**The Great Grid Upgrade**

Norwich to Tilbury

2022 Non-statutory Consultation Feedback Report

June 2023

Figure 3.22- Thurrock section map

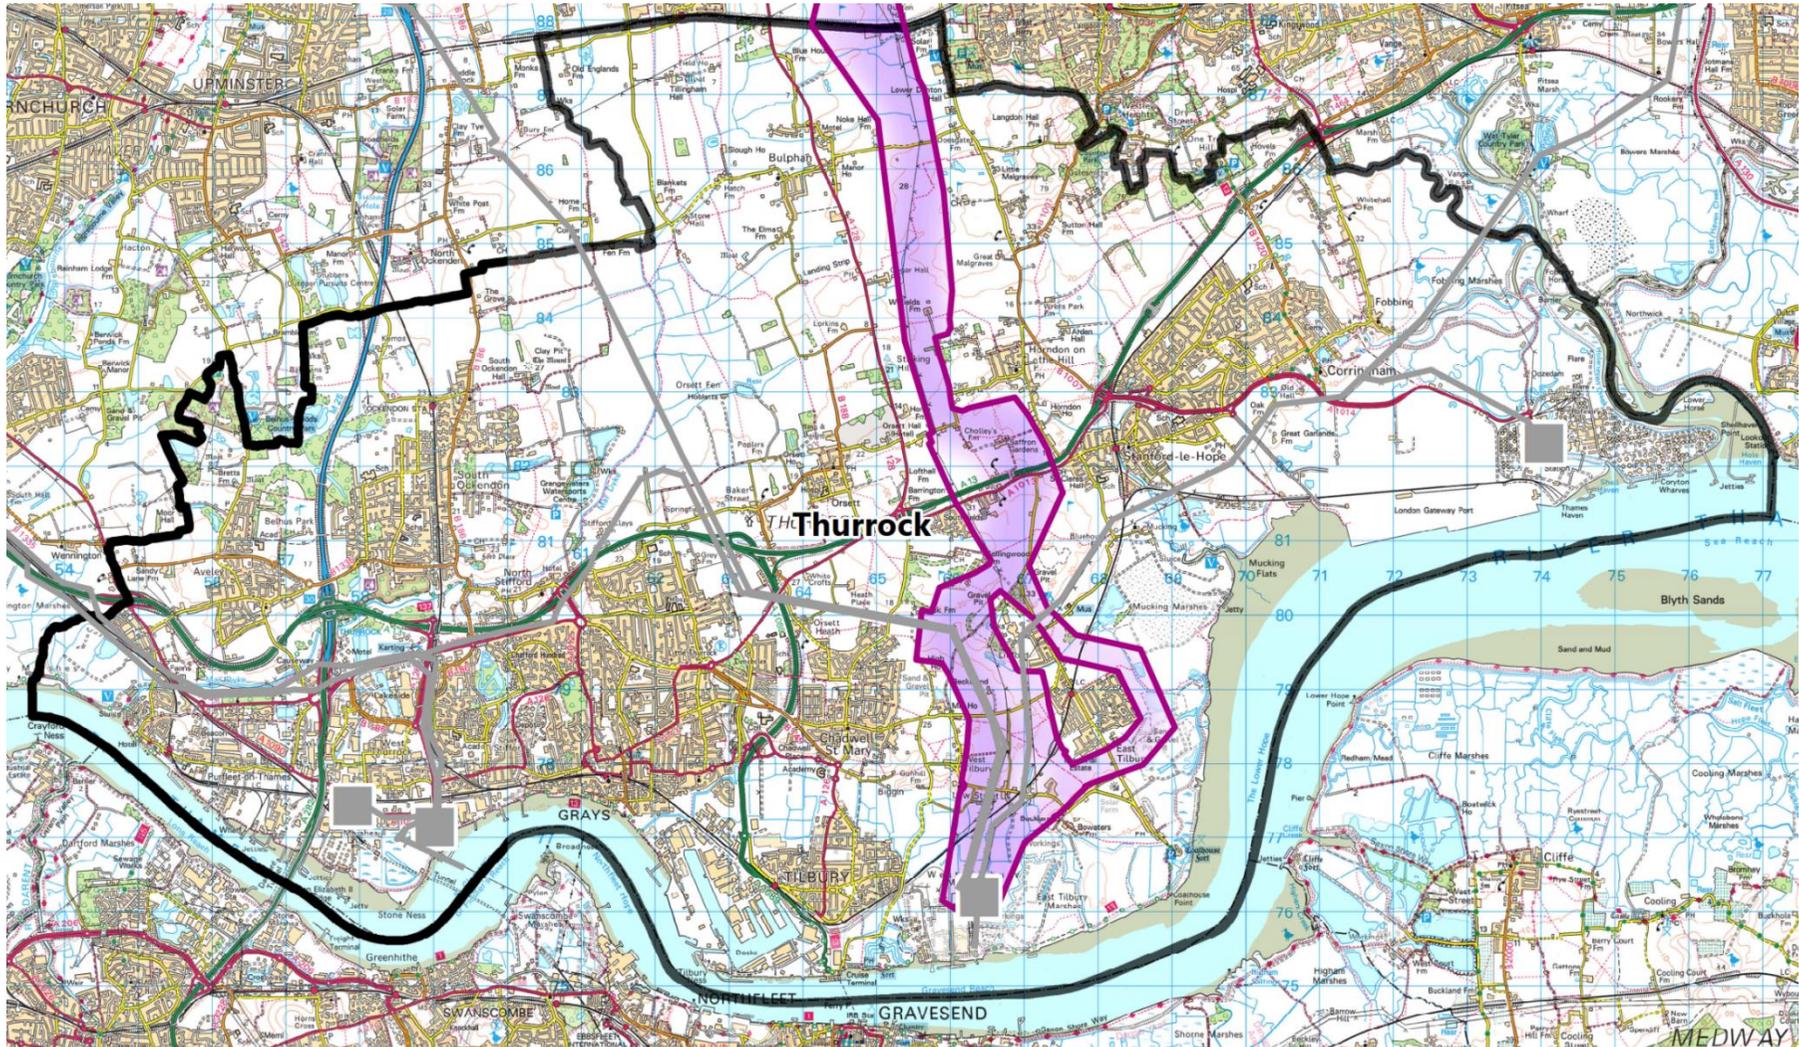
Ref no.	Summary of matters raised	National Grid's response
Community / Social impact		
3.9.1	Cumulative effect of the Project with other projects that are not being led by National Grid within this section (mineral extraction, expanding free port, new power station, etc)	<p>National Grid will as part of the Environmental Statement (ES) for the Project undertake a cumulative impact assessment in accordance with the Planning Inspectorate's Advice Note Seventeen. This, in summary, is a four stepped process and involves the production of a long list (Stage 1) generated from existing/ and or approved development(s) taking into consideration defined Zones of Influence for each environmental topic to be assessed within the Environmental Impact Assessment (EIA) of the Project.</p> <p>This long list will be refined into a short list based upon a range of factors including; the potential for interactions between the projects to occur, the level of environmental information/ assessment already undertaken by that development that is within the public domain and the certainty (i.e. planning status) of that development occurring (Stage 2 to 3). Upon completion of the short list a cumulative impact assessment (Stage 4) will be undertaken of the Project and those short-listed developments. Identified effects and any subsequent mitigation measures (if necessary) will be presented within the ES.</p> <p>We will engage with stakeholders such as Local Planning Authorities to understand the other relevant proposed developments in the Project area that should be included in the long/short list for assessment, such as solar farms, housing developments and major roads. We will work closely with other developers where there may be a cumulative impact to ensure that we understand their proposals so that these can be considered in our own assessment.</p>

Figure 3.23- South Norfolk section map

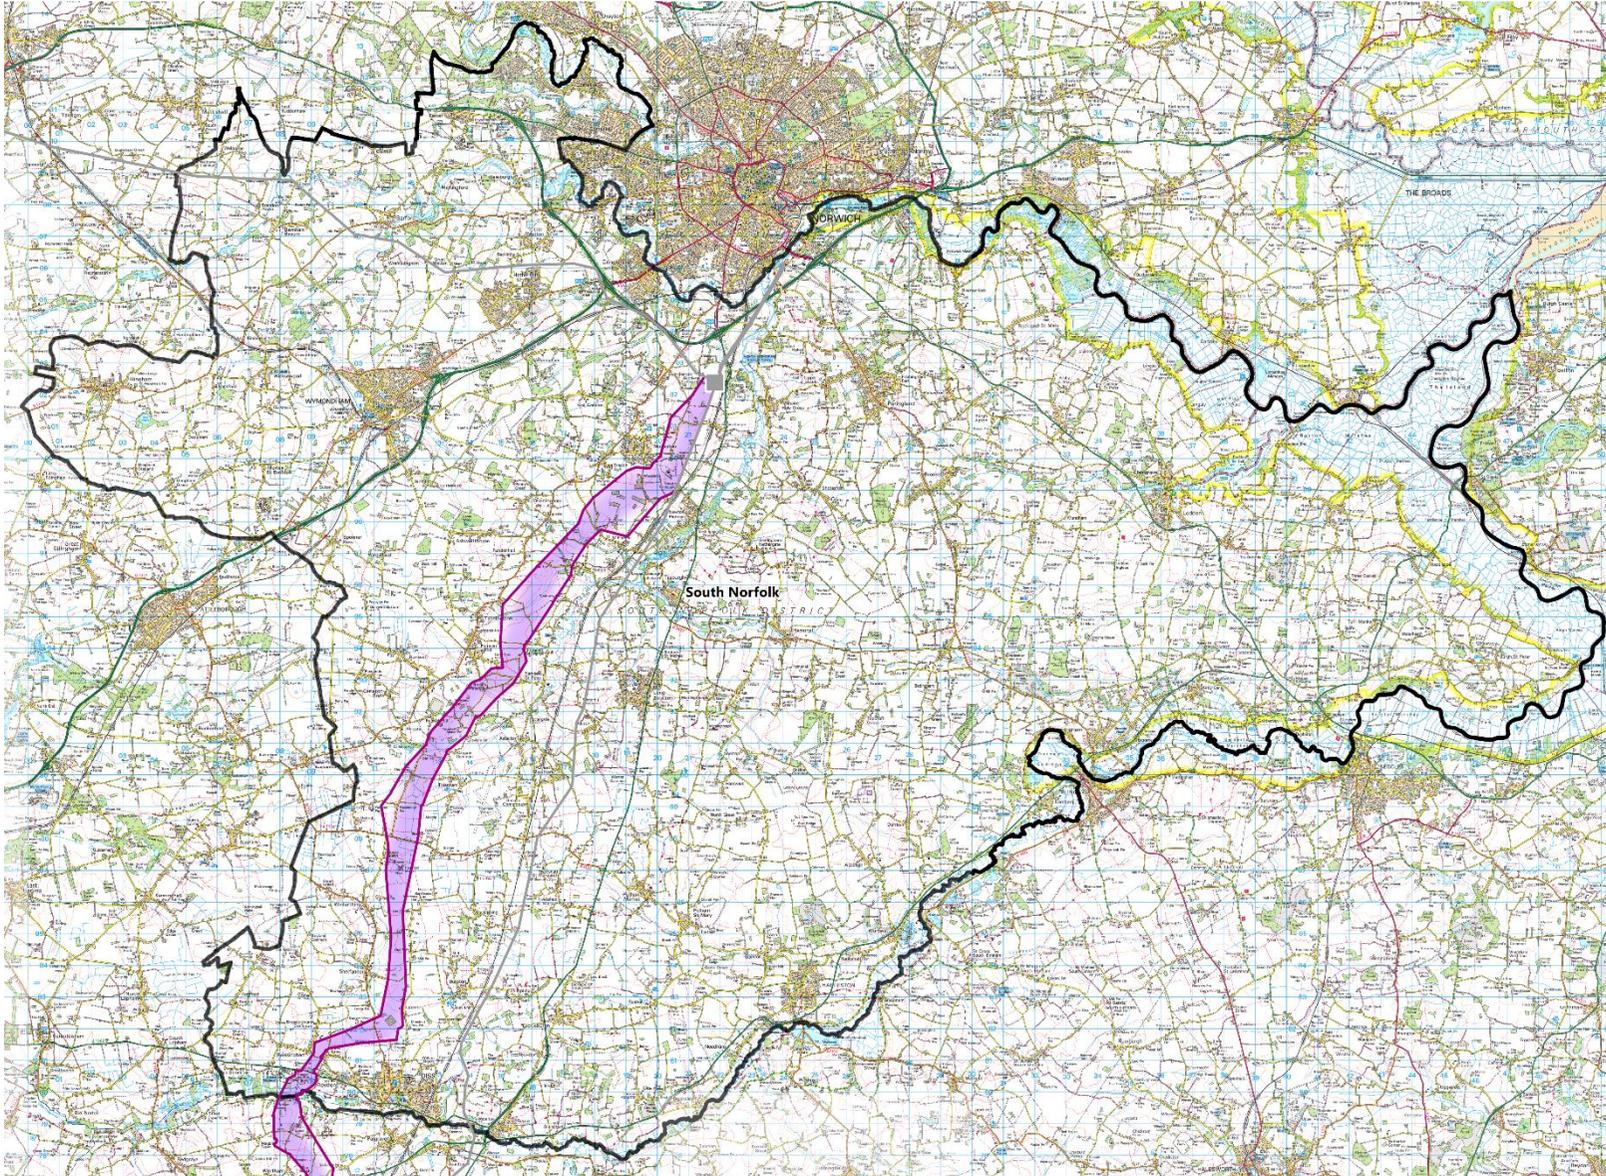
Ref no.	Summary of matters raised	National Grid's response
Agricultural land		
3.11.1	The Project will be taking away valuable agricultural land / disrupt farming operations	<p>National Grid recognises that there is the potential for impacts. We look to limit the impact on agricultural land through careful and considered routeing and siting of infrastructure and through consultation with affected landowners. We are and will continue to work with all landowners including farmers who may be affected by the proposals to understand the potential impacts on their operations and to work with them as the Project is developed. We will seek to work with the farming community to limit disruption where practicable. This includes providing prior warning of works which may result in the need to move livestock. Compensation claims for disturbance are considered on a case-by-case basis. Particular agricultural matters can also be written into voluntary land agreements.</p>

Figure 3.24- Mid Suffolk section map

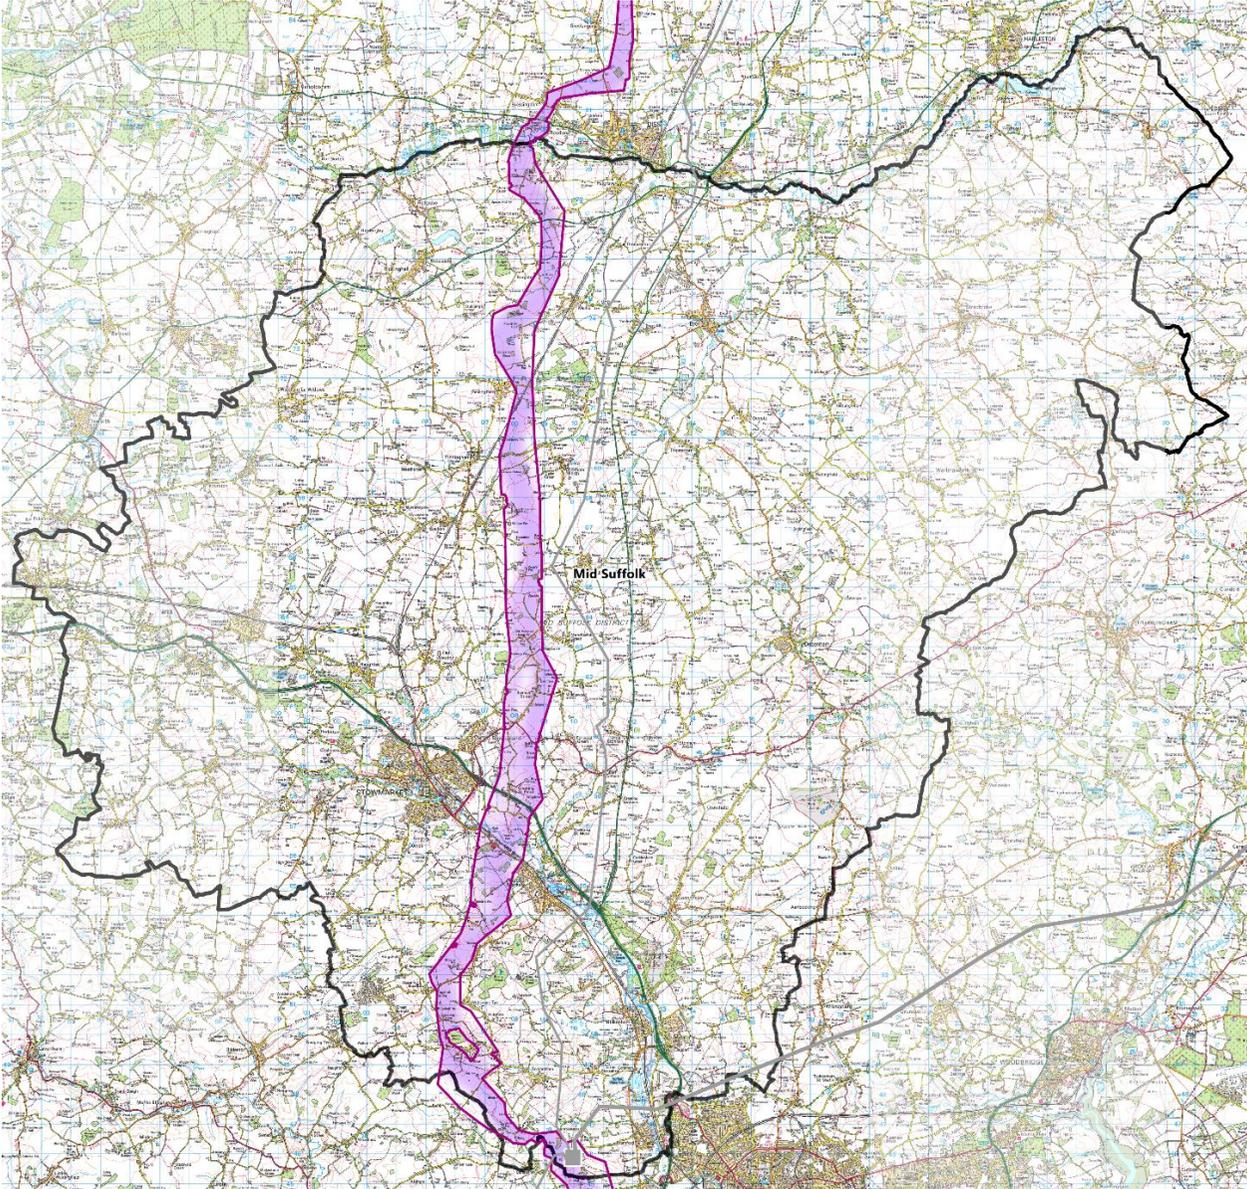
Ref no.	Summary of matters raised	National Grid's response
Agricultural land		
3.12.1	The Project will be taking away valuable agricultural land / disrupt farming operations	National Grid recognises that there is the potential for impacts. We look to limit the impact on agricultural land through careful and considered routeing and siting of infrastructure and through consultation with affected landowners. We are and will continue to work with all landowners including farmers who may be affected by the proposals to understand the potential impacts on their operations and to work with them as the Project is developed. We will seek to work with the farming community to limit disruption where practicable. This includes providing prior warning of works which may result in the need to move livestock. Compensation claims for disturbance are considered on a case-by-case basis. Particular agricultural matters can also be written into voluntary land agreements.

Figure 3.25- Babergh, Tendring and Colchester section map

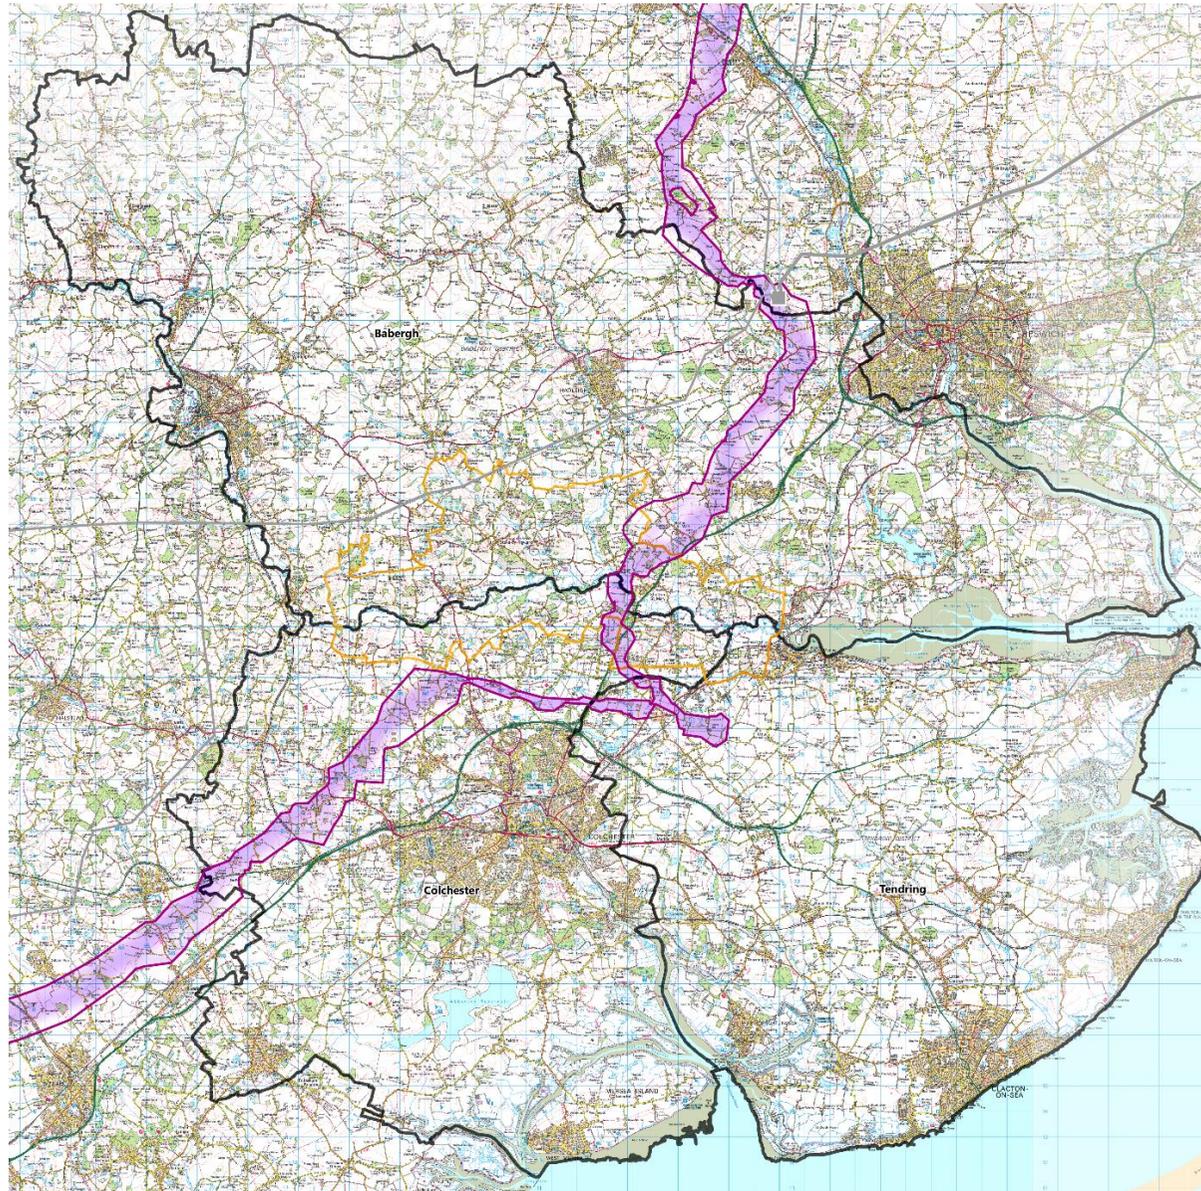
Ref no.	Summary of matters raised	National Grid's response
Agricultural land		
3.13.1	The Project will be taking away valuable agricultural land / disrupt farming operations	<p>National Grid recognises that there is the potential for impacts. We look to limit the impact on agricultural land through careful and considered routing and siting of infrastructure and through consultation with affected landowners. We are and will continue to work with all landowners including farmers who may be affected by the proposals to understand the potential impacts on their operations and to work with them as the Project is developed. We will seek to work with the farming community to limit disruption where practicable. This includes providing prior warning of works which may result in the need to move livestock. Compensation claims for disturbance are considered on a case-by-case basis. Particular agricultural matters can also be written into voluntary land agreements.</p>

Figure 3.26- Braintree section map

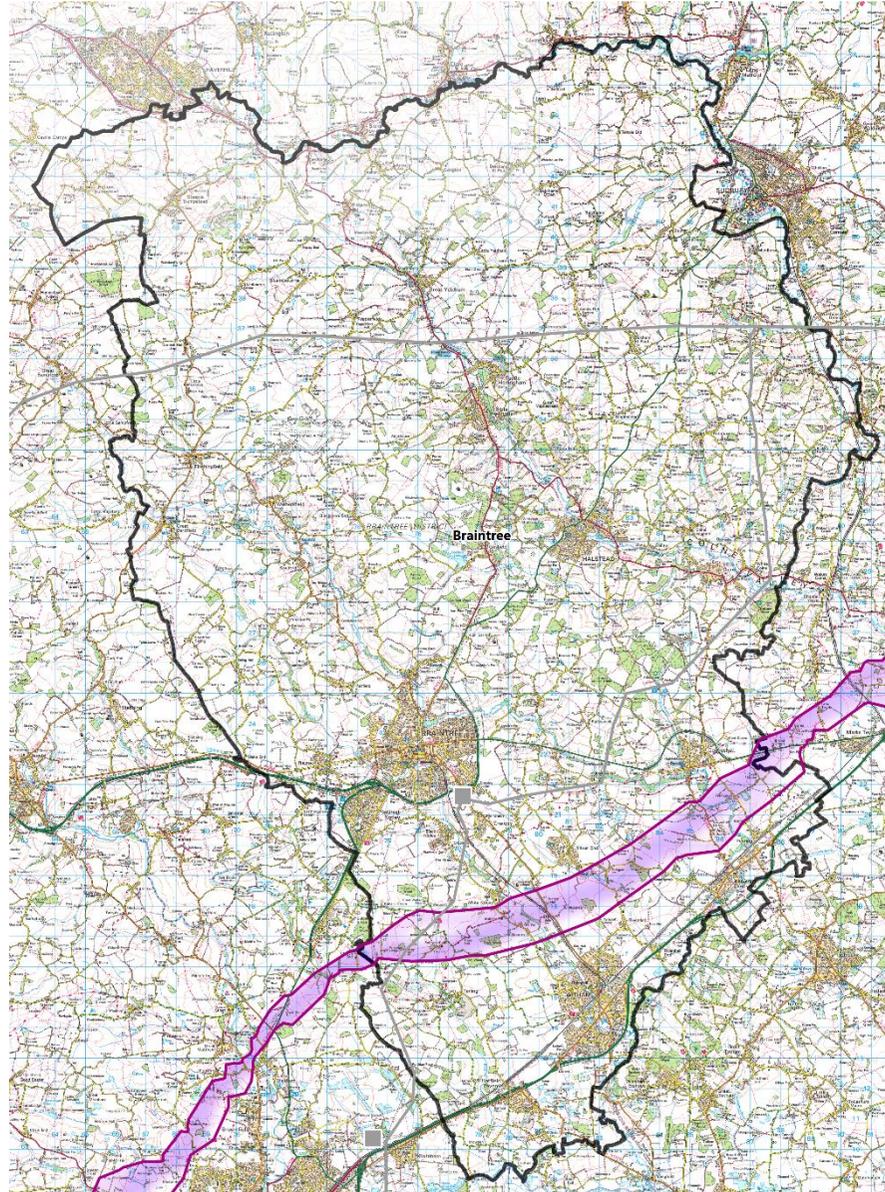
Ref no.	Summary of matters raised	National Grid's response
Agricultural land		
3.14.1	The Project will be taking away valuable agricultural land / disrupt farming operations	National Grid recognises that there is the potential for impacts. We look to limit the impact on agricultural land through careful and considered routeing and siting of infrastructure and through consultation with affected landowners. We are and will continue to work with all landowners including farmers who may be affected by the proposals to understand the potential impacts on their operations and to work with them as the Project is developed. We will seek to work with the farming community to limit disruption where practicable. This includes providing prior warning of works which may result in the need to move livestock. Compensation claims for disturbance are considered on a case-by-case basis. Particular agricultural matters can also be written into voluntary land agreements.

Figure 3.27- Chelmsford section map

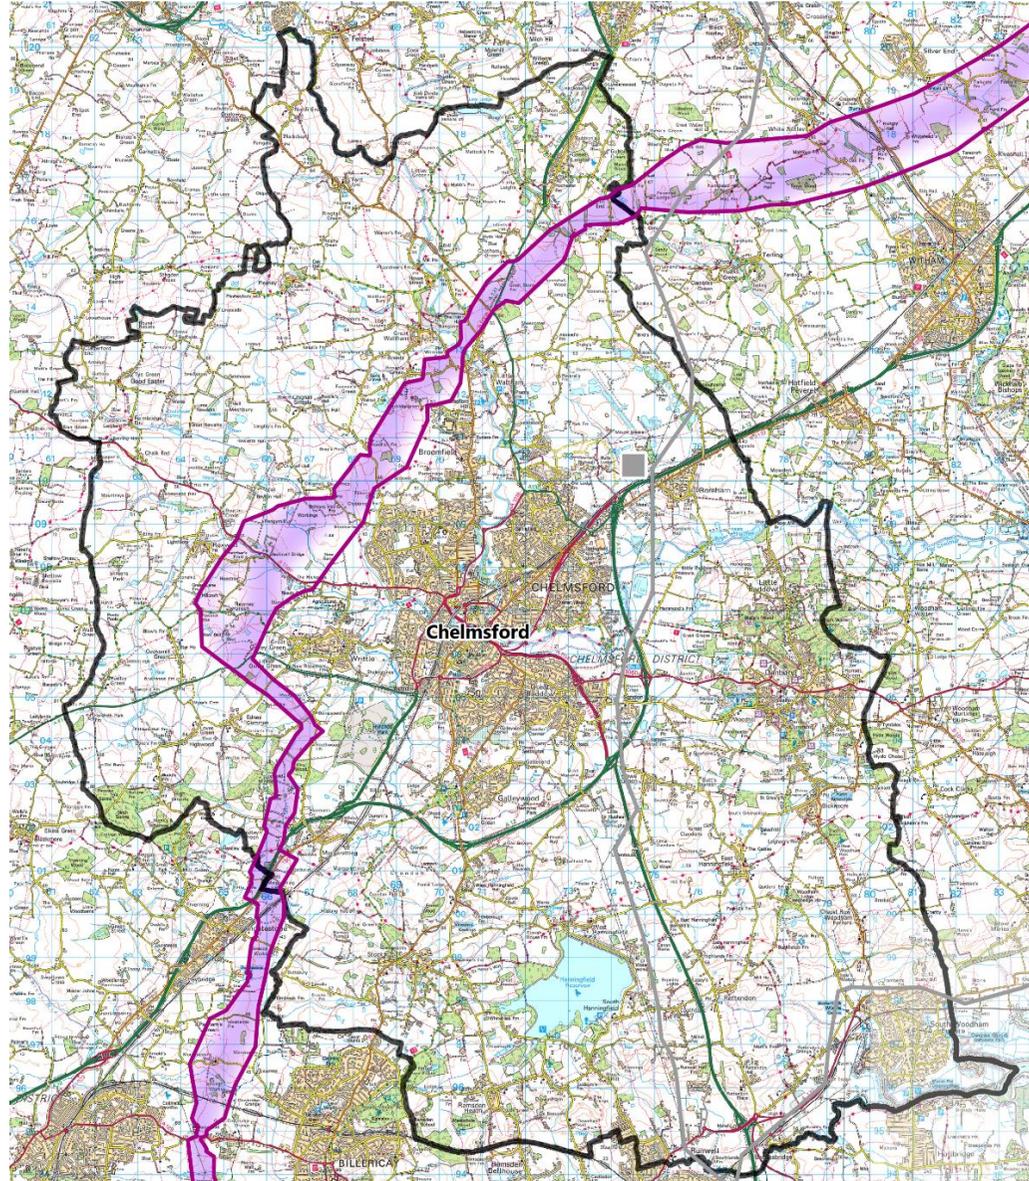
Ref no.	Summary of matters raised	National Grid's response
Agricultural land		
3.15.1	The Project will be taking away valuable agricultural land / disrupt farming operations	National Grid recognises that there is the potential for impacts. We look to limit the impact on agricultural land through careful and considered routeing and siting of infrastructure and through consultation with affected landowners. We are and will continue to work with all landowners including farmers who may be affected by the proposals to understand the potential impacts on their operations and to work with them as the Project is developed. We will seek to work with the farming community to limit disruption where practicable. This includes providing prior warning of works which may result in the need to move livestock. Compensation claims for disturbance are considered on a case-by-case basis. Particular agricultural matters can also be written into voluntary land agreements.
